THESE DRAWINGS AND SPECIFICATIONS ARE THE PROPERTY OF CARDINALT INC. AND SHALL NOT BE REPRODUCED, COPIED, OR USED FOR MANUFACTURE OR SALE OF APPARATUS WITHOUT WRITTEN PERMISSION OF CARDINALT INC.										TOLERANCES AND SYMBOLOGY FINISH AND TOLERANCES ARE AFTER ADDITIVE FINISH.		ANGLES ± 2°		SURF. FINISH --		MATERIAL ALUM		ORIGINATOR DATE		DRAWN CROSS DATE 09/18/08		PART NO. 004100-079		I / I SHT. OF 03	
 10811 Collins Avenue Lakewood, Colorado 80225-4440 USA										TITLE BASE, BAG POLE

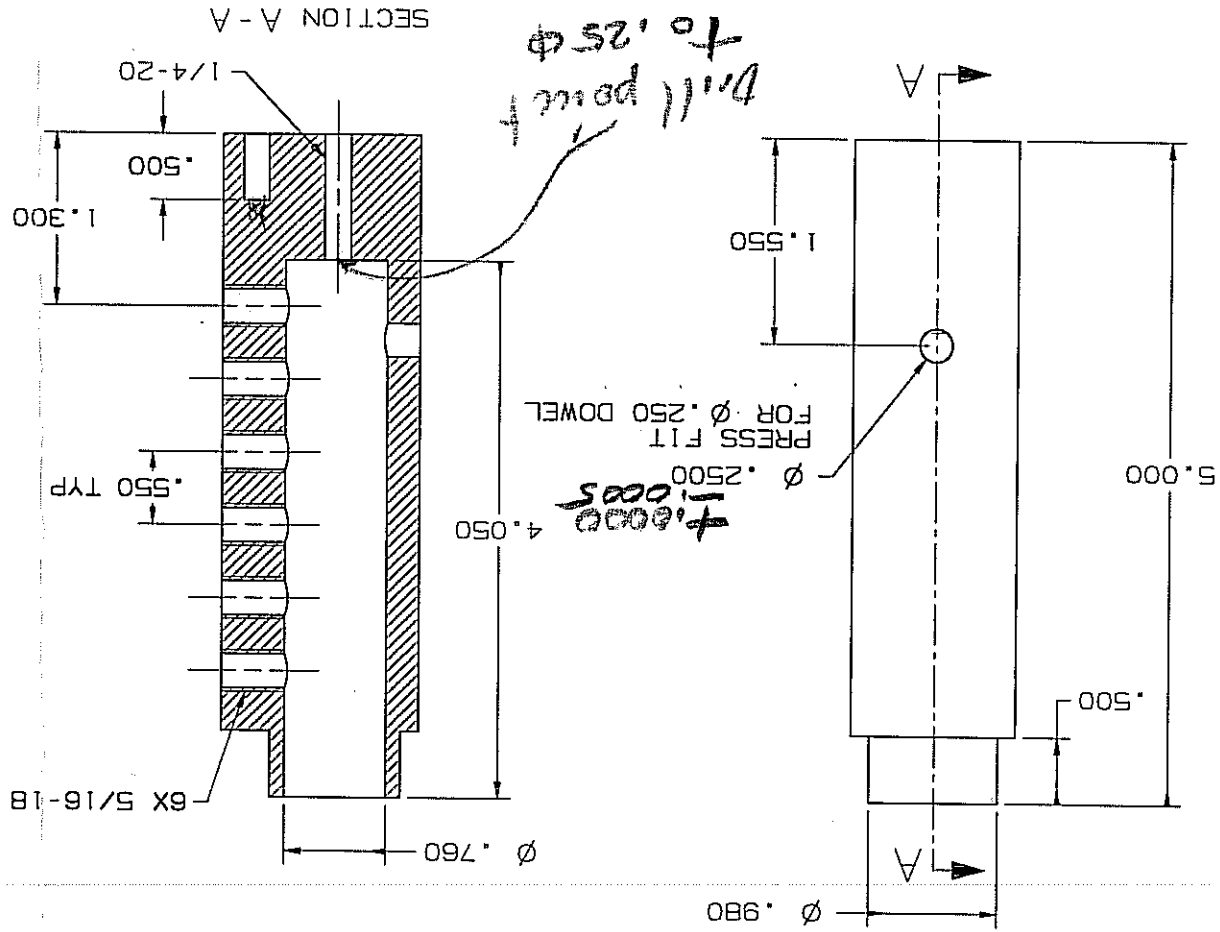
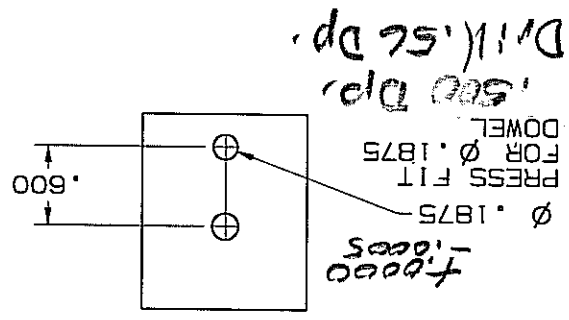
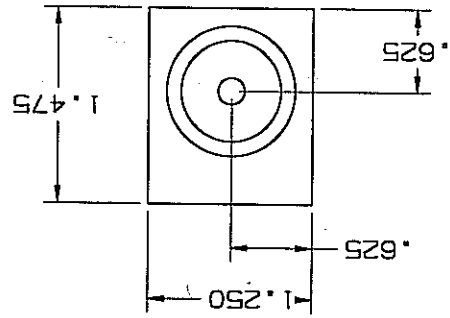
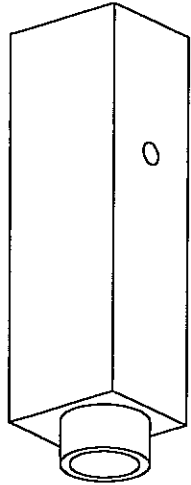
REV	REVISION DESCRIPTION	BY	DATE	ECO #
01	PROTOTYPE	③	80/81/80	BCT
02	INCREASES DIAMETERS FOR Ø.75 POLE	③	80/82/80	BCT
03	MADE BASE RECT: ADDED 5/16-18, Ø.1875, Ø.2500; 1/4-20 WAS 8-32; 5.00 WAS 2.50	③	80/82/81	BCT
